RE: Hope Christian School – Elementary
6721 Palomas Ave. NE
Grading and Drainage Plan
Engineer's Stamp Date: 02/21/19
Hydrology File: D18D009A

Based upon the information provided in your submittal received 02/22/2019, the Conceptual Grading Plan and Drainage Report **is not** approved for action by the DRB for Site Plan for Building Permit. The following comments need to be addressed for approval of the above referenced project:

1 SITE GRADING PLAN - ENLARGED
1" = 20'-0"

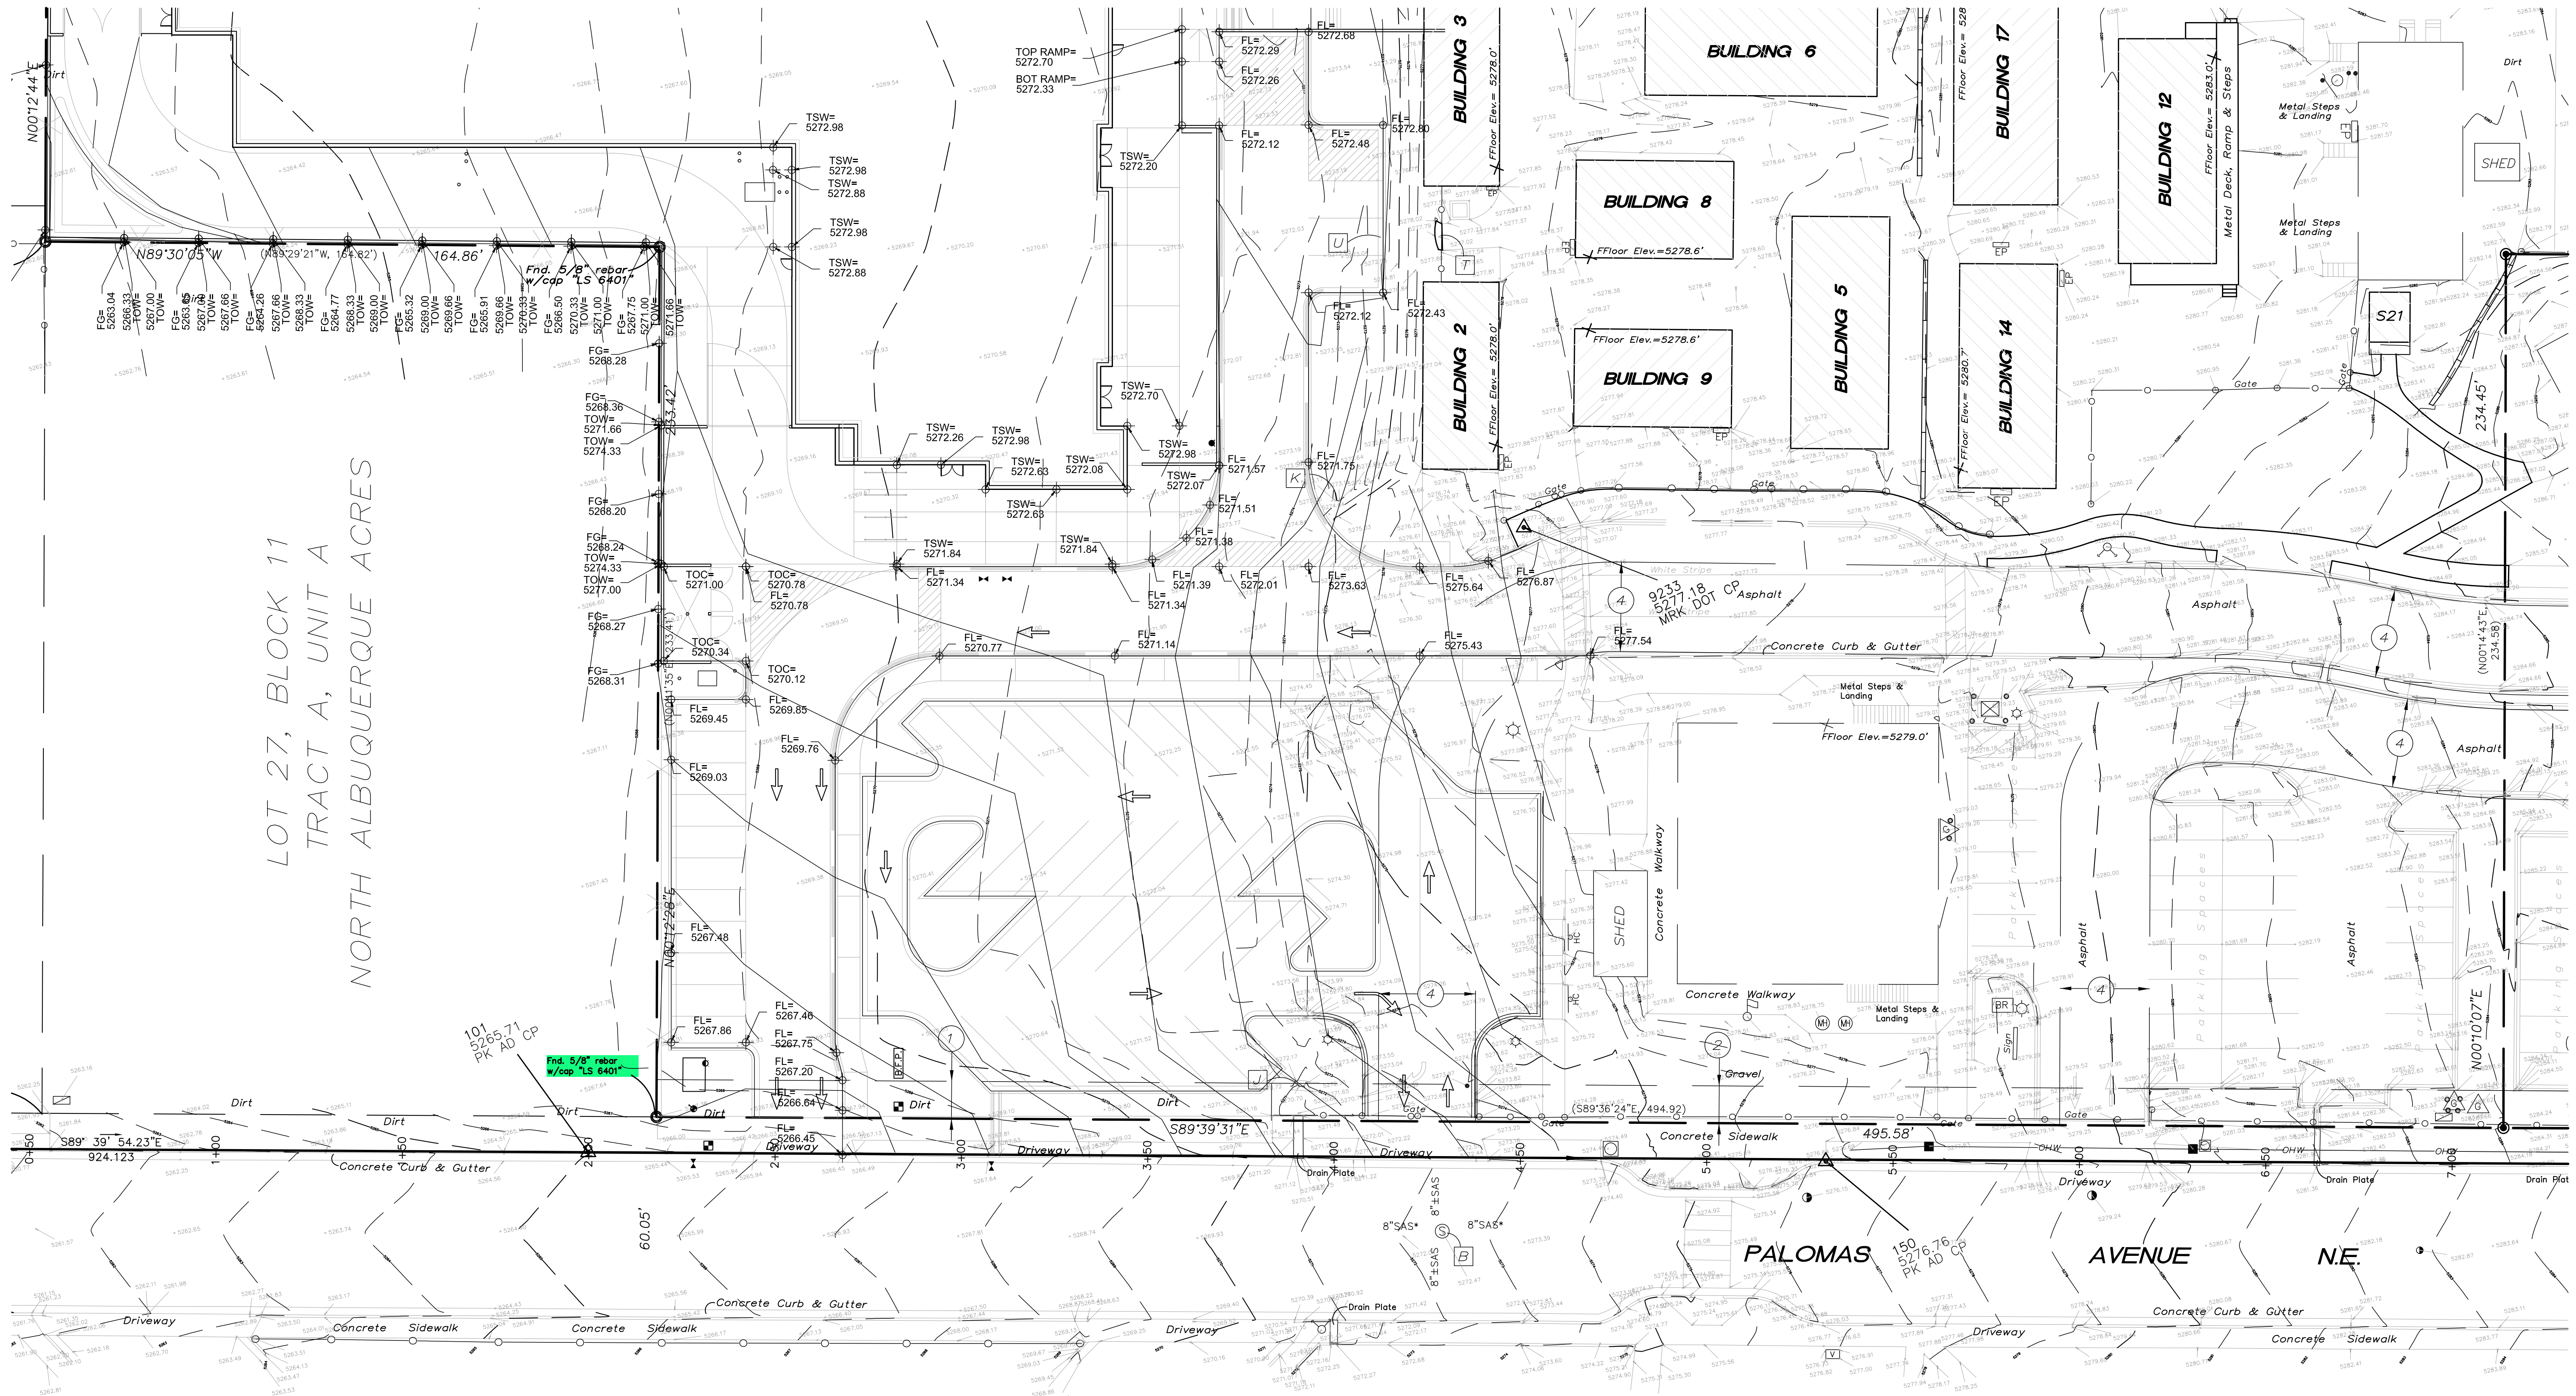
8. Sheet CD-2. Please fix Drainage Areas EX3 and EX4 to show the existing paving draining through the existing sidewalk culvert in Drainage Area EX4.
9. Sheet C-203. Please add some flowline information within the proposed parking lot.

10. Sheet C-203. Please label the proposed sidewalk culvert.
11. As a reminder, if the project total area of disturbance (including the staging area and any work within the adjacent Right-of-Way) is 1 acre or more, then an Erosion and Sediment Control (ESC) Plan and Owner's certified Notice of Intent (NOI) is required to be submitted to the Stormwater Quality Engineer (Curtis Cherne, PE, ccherne@cabq.gov, 924-3420) 14 days prior to any earth disturbance.
